BID PACKAGE 02 – ADDENDUM 01**Date:** January 10, 2020**Re:** Wilma P Mankiller Health Center Expansion**From:** James R Childers Architect, Inc.
45 South 4th Street
Fort Smith, Arkansas 72901

CHANGE NARRATIVE LETTER

TO: MATHEW THOMAS- CHILDERS ARCHITECTS
FROM: STEPHEN EDMONDSON, TREY SMITH, BETSY WELLS– HP ENGINEERING, INC.
DATE: 1/10/2020
PROJECT: WPMHC EXPANSION BID PACKAGE 02 ADDENDUM 01

E1.04
 POWER PLAN
 LEVEL 02
 SECTOR 01

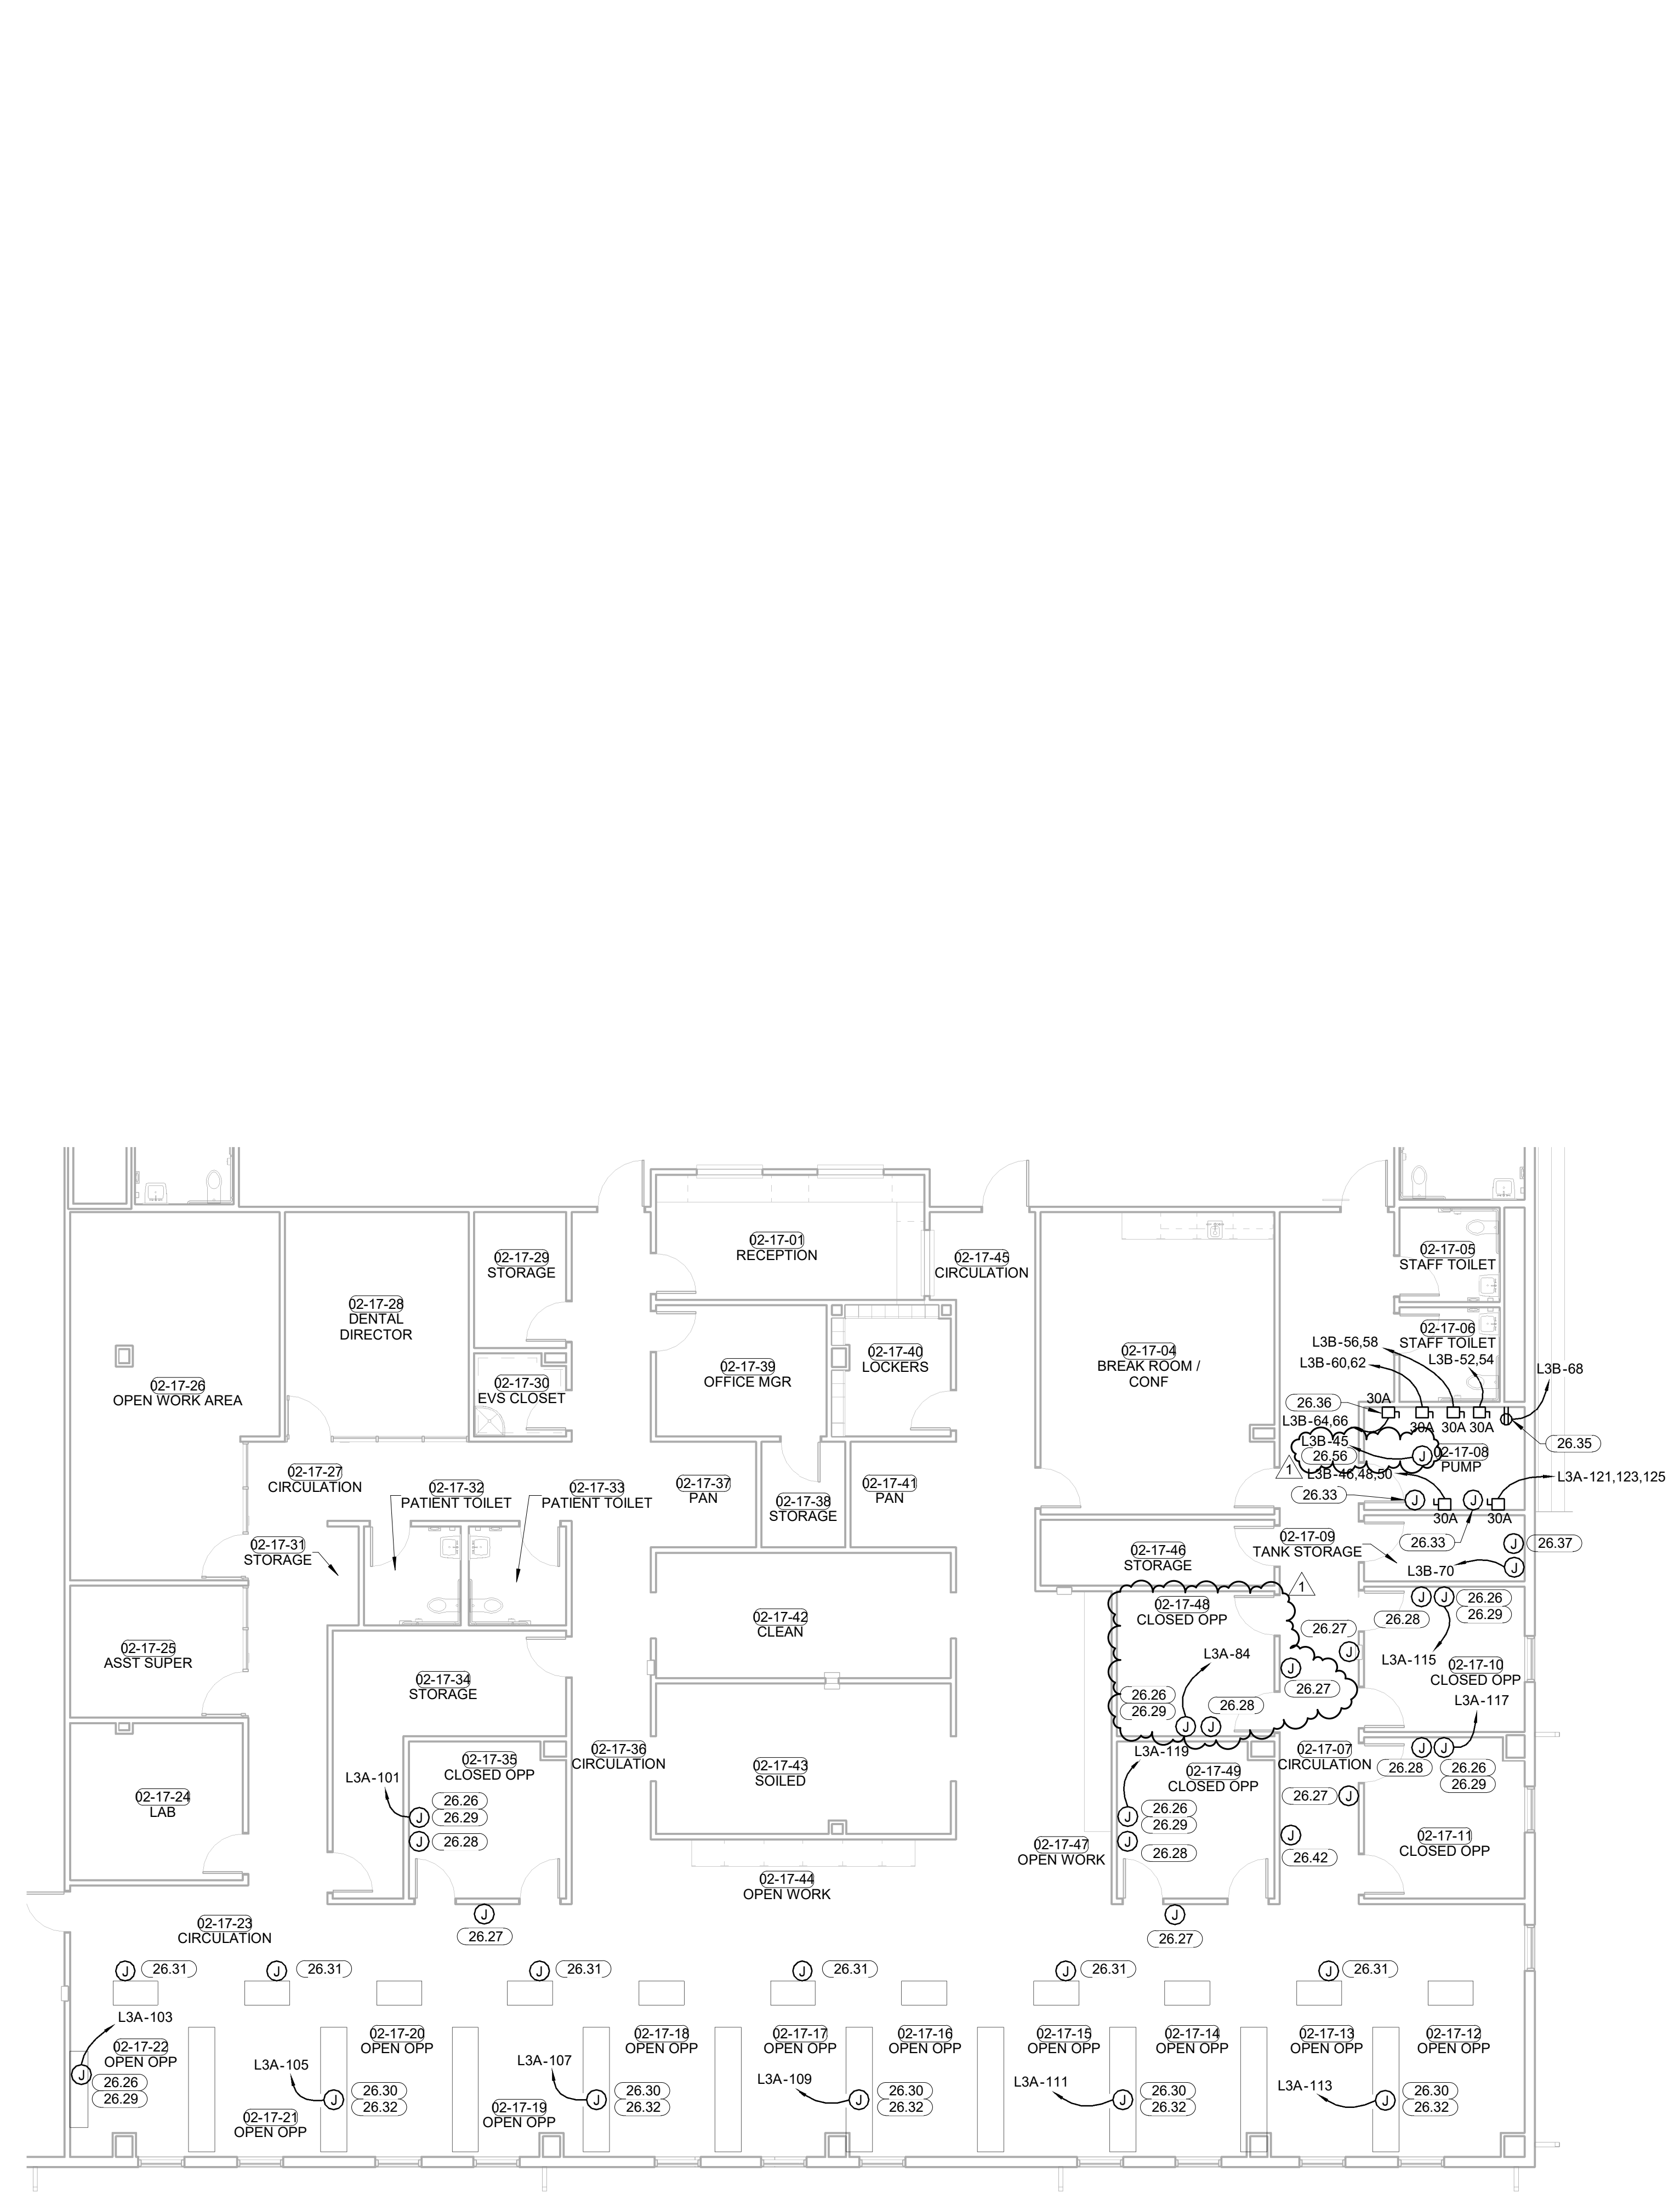
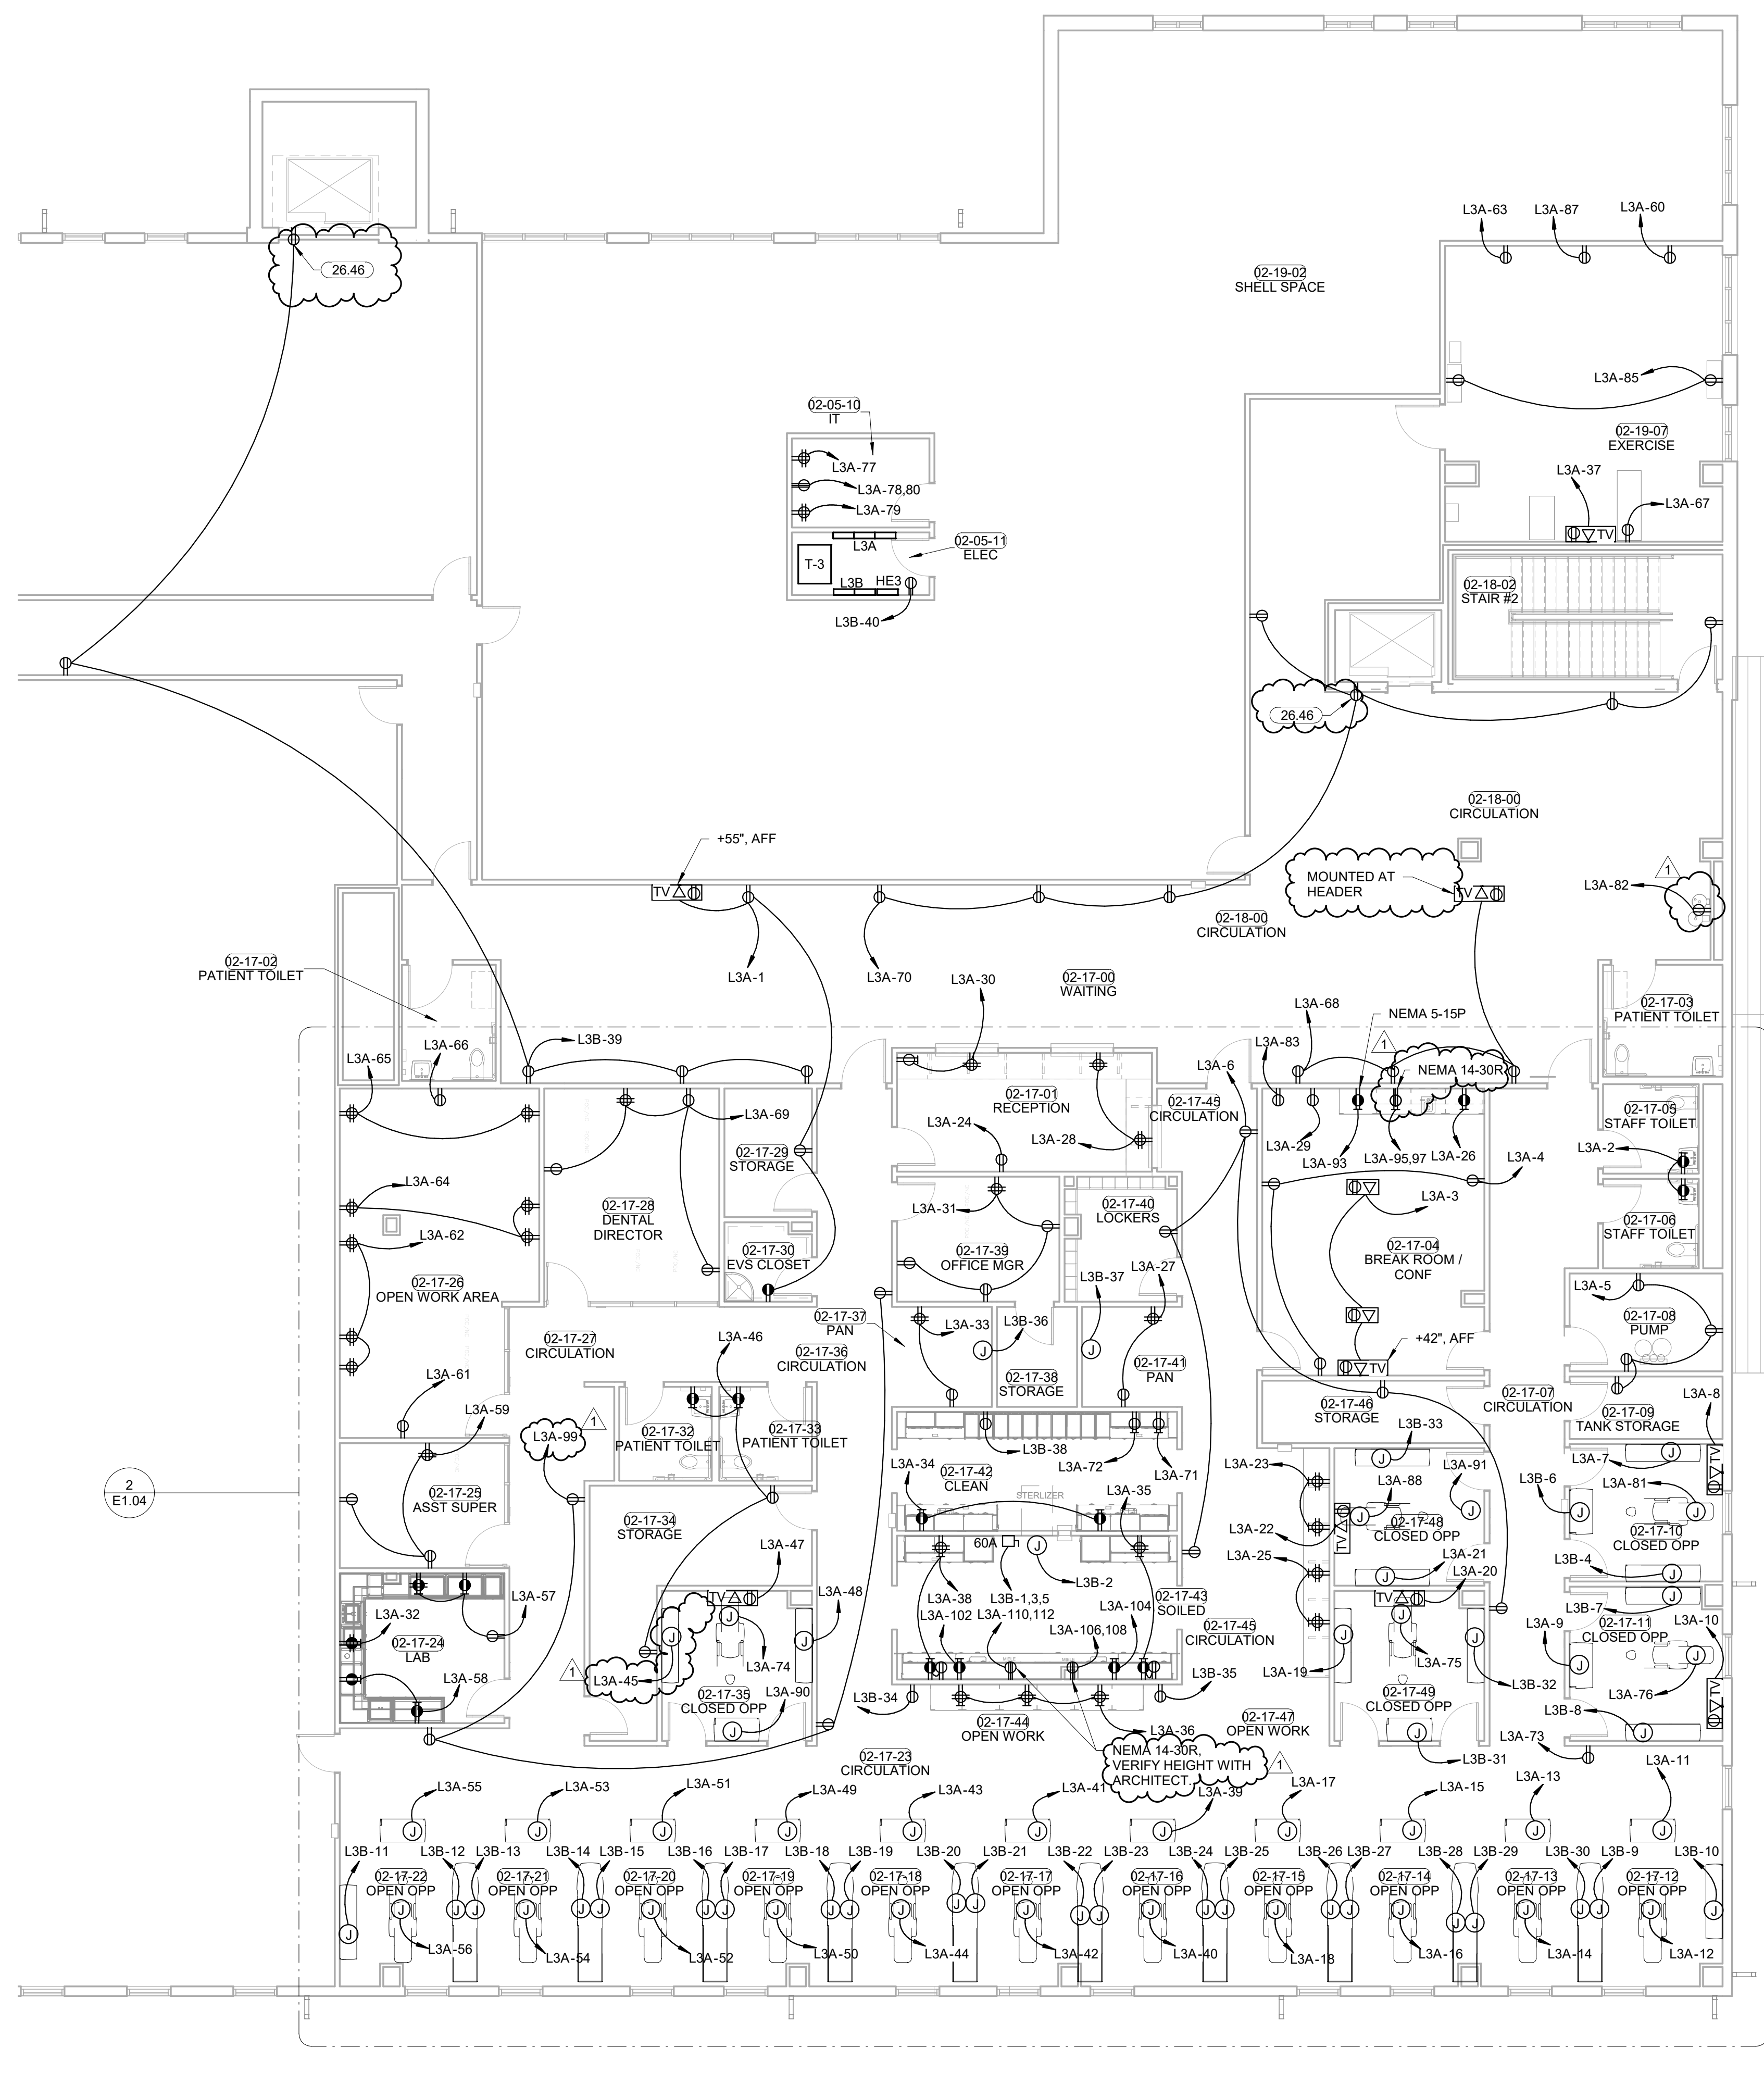
1. E1.01
 - a. Notes updated
2. E1.03
 - a. H1 panel relocated.
3. E1.04
 - a. Detail 1 – Revised water fountain receptacle to not be GFI.
 - b. Detail 1 – Added (1) circuit in Closed Opp 02-17-35 for receptacles.
 - c. Detail 1 – Revised circuit number for Circulation 02-17-27 receptacles.
 - d. Detail 1 – Revised note for miele instrument washer receptacles in Soiled 02-17-43 to include NEMA type.

- e. Detail 1 – Added NEMA rating for coffee receptacle in Breakroom/Conf 02-17-04.
 - f. Detail 2 – Revised orientation of detail.
 - g. Detail 2 – Added (1) junction box for x-ray in Closed Opp 02-17-48.

- h. Detail 2 – Added (1) junction for remoted station in Closed Opp 02-17-48.
 - i. Detail 2 – Added (1) junction for exposure button in Circulation 02-17-07.

- j. Keynotes – Removed keynote 26.39.
4. E1.05
- a. Detail 1 – Added keynote 26.46 to elevator service GFCI receptacle.
 - b. Keynotes – Added to sheet.

SHEET NUMBER:
E2.06

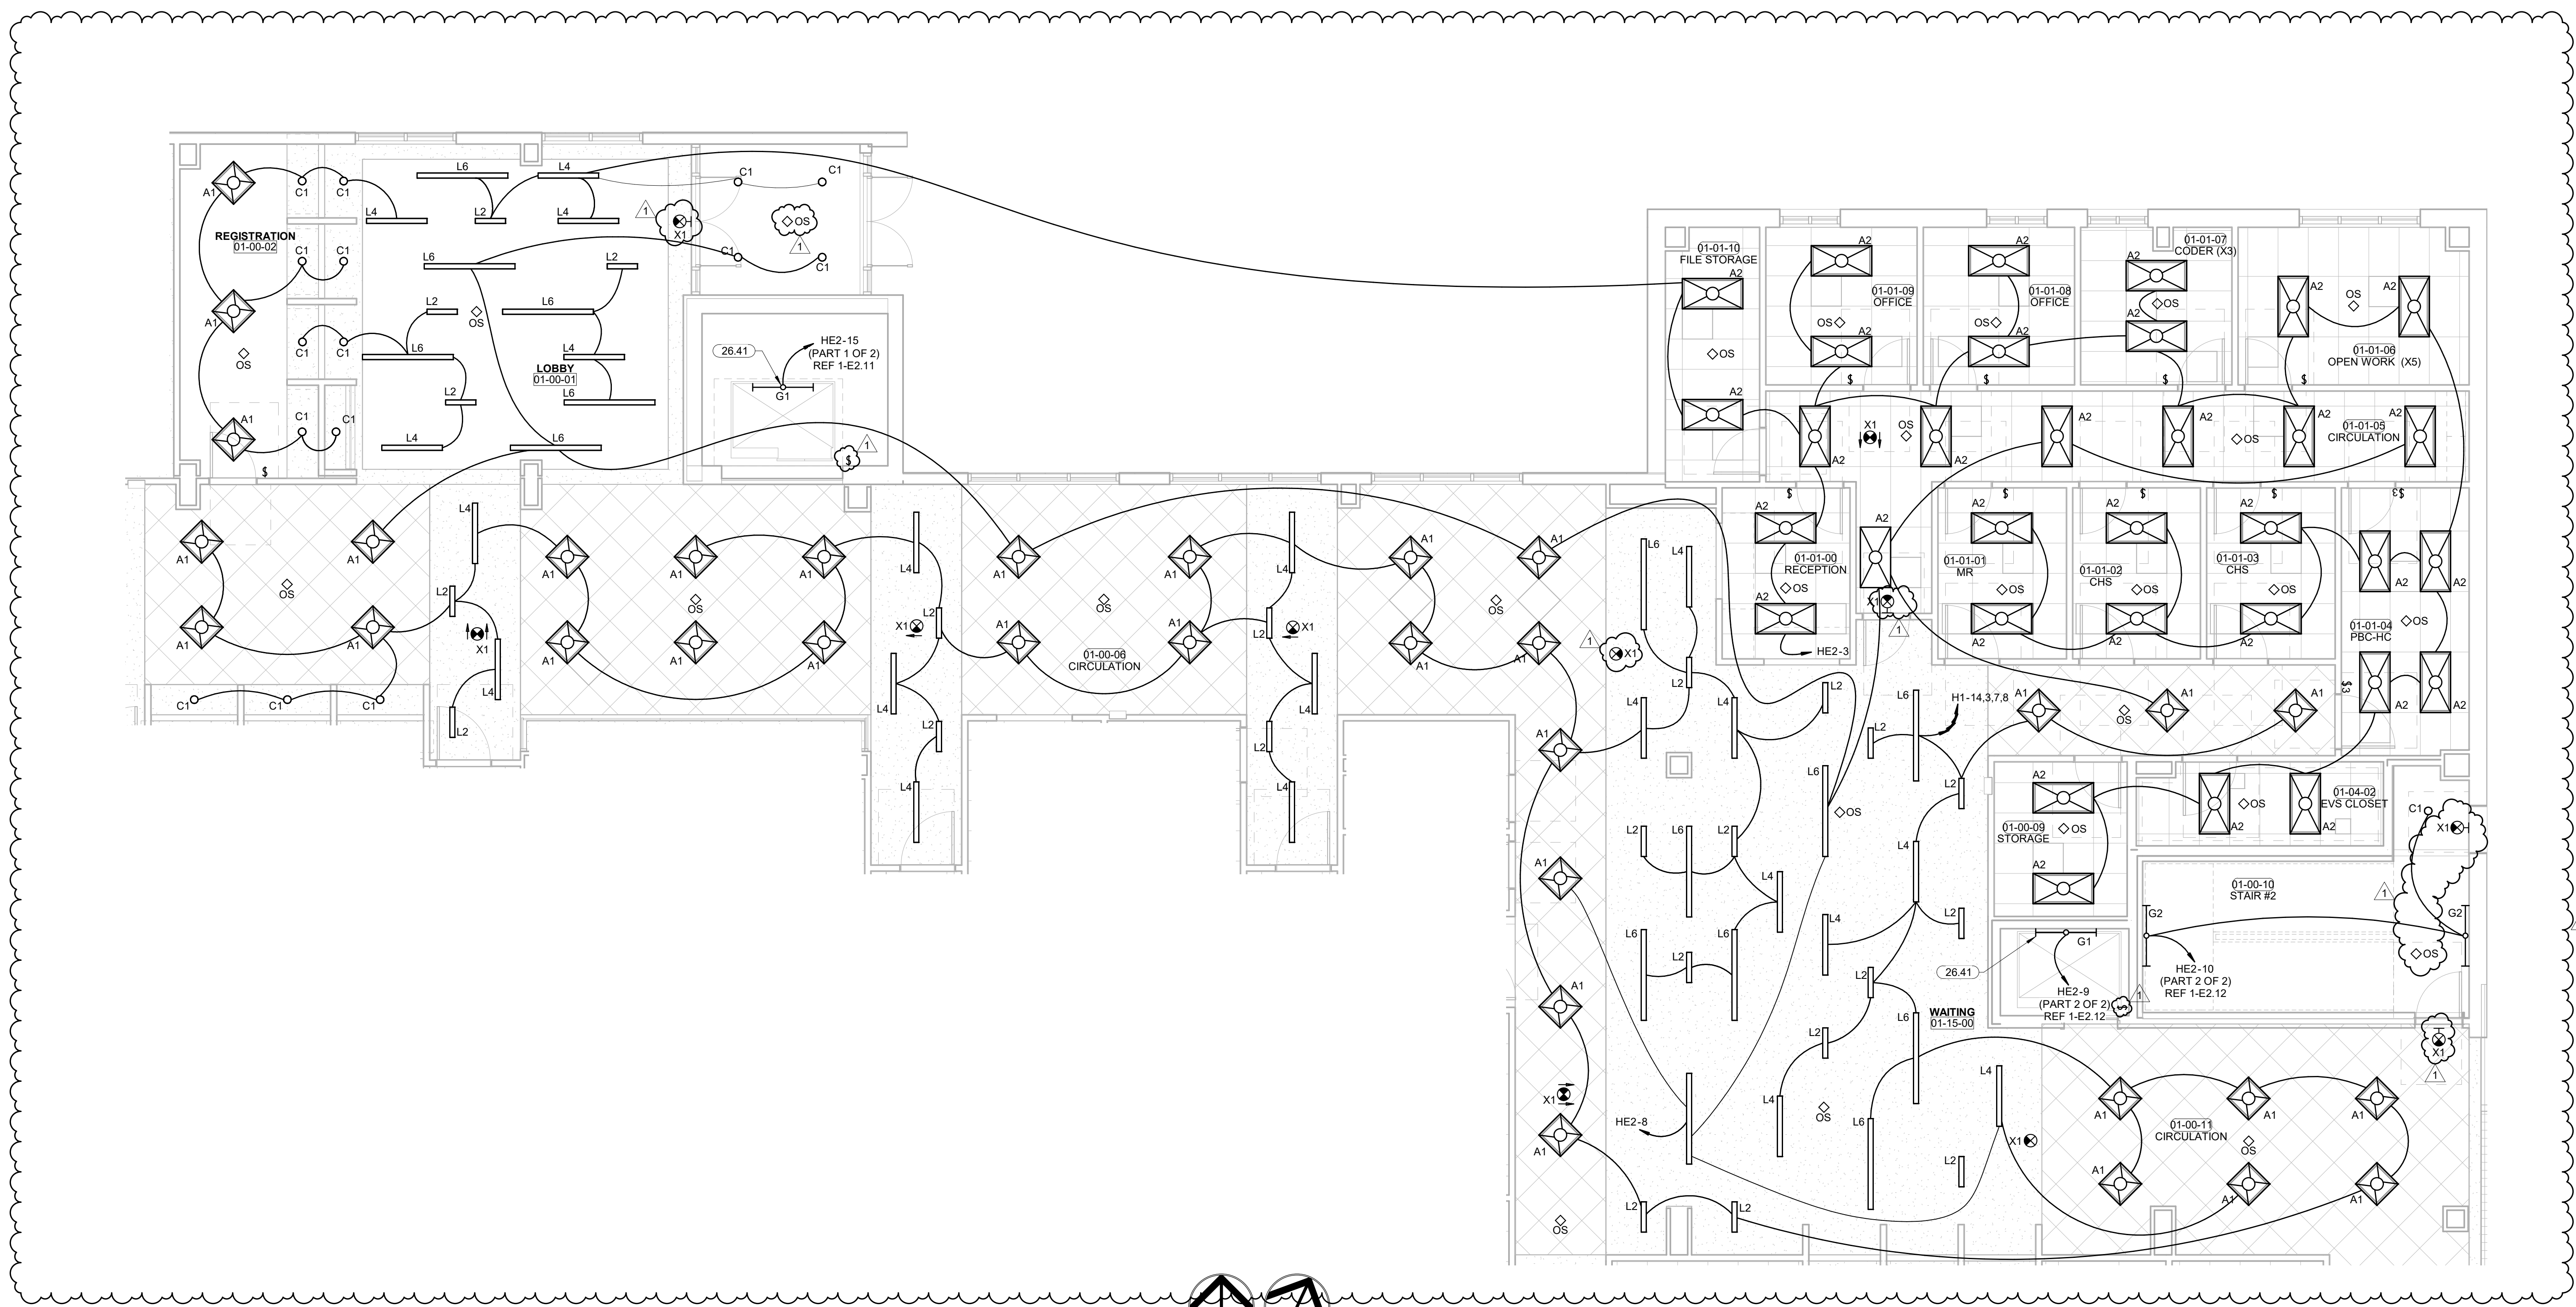
- a. Circuits have been updated.
- 25. E2.05
 - a. Detail 1 – Revised all wires to be shown as dashed.
- 26. E2.06
 - a. Detail 1 – Revised location of ceiling OS in Stair #2 01-00-10.

- b. Detail 1 – Revised location of Type X1 fixture in Stair #2 01-00-01.
 - c. Detail 1 – Added light switch for (2) elevators.
 - d. Detail 1 – Added (1) Type X1 fixture to Circulation 01-00-11.

- e. Detail 1 – Revised location of ceiling OS in Circulation 01-00-11.
 - f. Detail 1 - Added (1) Type X1 fixture to Circulation 01-01-05.
 - g. Detail 1 – Added (1) Type X1 fixture to Circulation 01-00-06.

- h. Detail 1 – Added (1) Type X1 fixture to Lobby 01-00-01.
 - i. Detail 1 – Added (1) ceiling OS to Vestibule.
 - j. Keynotes – Added to sheet.
